SPRINGHILL ESTATES SUBDIVISION, A RE-SUBDIVISION OF LOTS 15-A, 16, 17, 18 & 19

APPLICATION NUMBER 12 DATE July 5, 2012

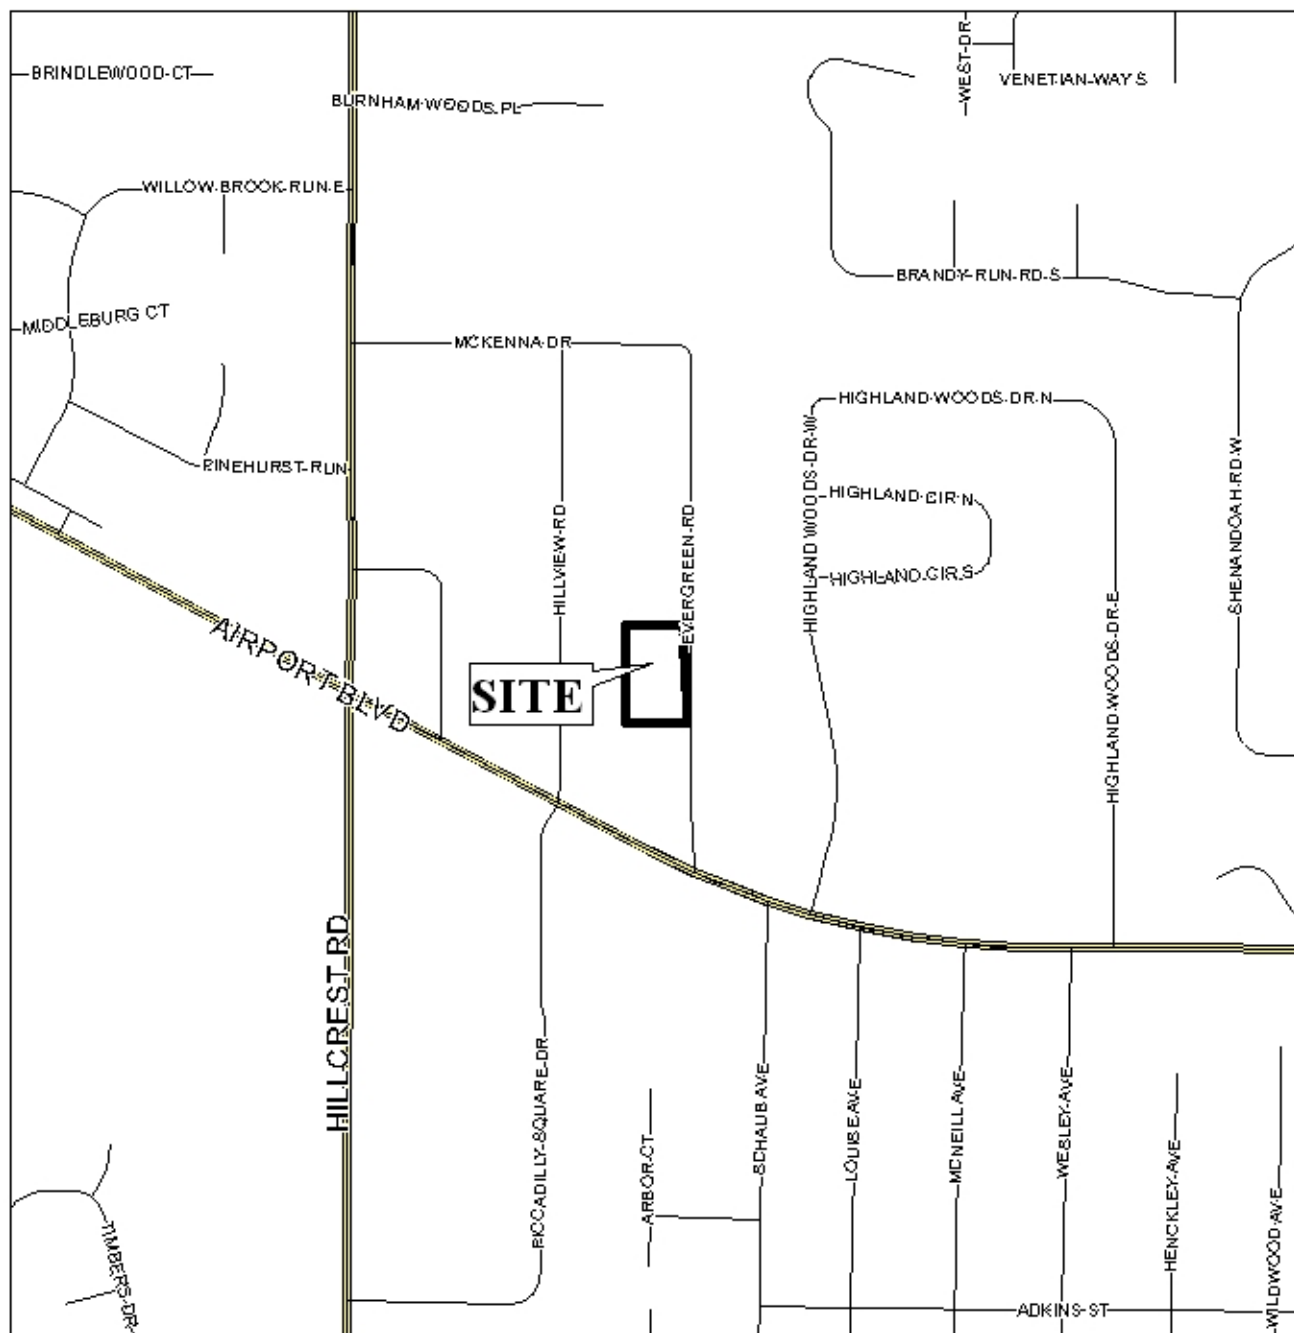
The site fronts onto Evergreen Road, a minor street with a varying right-of-way in this area; therefore, dedication to provide 25' from the centerline of Evergreen Road should be required where lacking. While it is a minor right-of-way, access management is a concern. Each lot should be limited to one curb cut onto Evergreen Road, with the size, design and location to be approved by Traffic Engineering and conform to AASHTO standards, if the subdivision is approved.

The common interior property line is proposed to be shifted 10' to the South, and each lot would meet the minimum area and width requirements of the Subdivision Regulations. As on the preliminary plat, the Final Plat should also label each lot with its size in both square feet and acres, after any required dedication, or a table should be furnished on the Final Plat providing the same information. It should be noted that the recorded 35' minimum building setback line on existing Lot 15-A is now proposed to be 25'; therefore, the 25' minimum building setback line should also be illustrated on the Final Plat as on the preliminary, measured from any required dedication.

- 1) dedication to provide 25' from the centerline of Evergreen Road where lacking;
- 2) placement of a note on the Final Plat stating that each lot is limited to one curb cut to Evergreen Road, with the size, design and location to be approved by Traffic Engineering and conform to AASHTO standards;

- 3) labeling of each lot with its size in acres and square feet, adjusted for any required dedication, or the furnishing of a table on the Final Plat providing the same information;

- 4) illustration of the 25' minimum building setback line on each lot, measured from any required dedication;
- 5) placement of a note on the Final Plat stating that development of this site must be undertaken in compliance with all local, state, and Federal regulations regarding endangered, threatened or otherwise protected species;
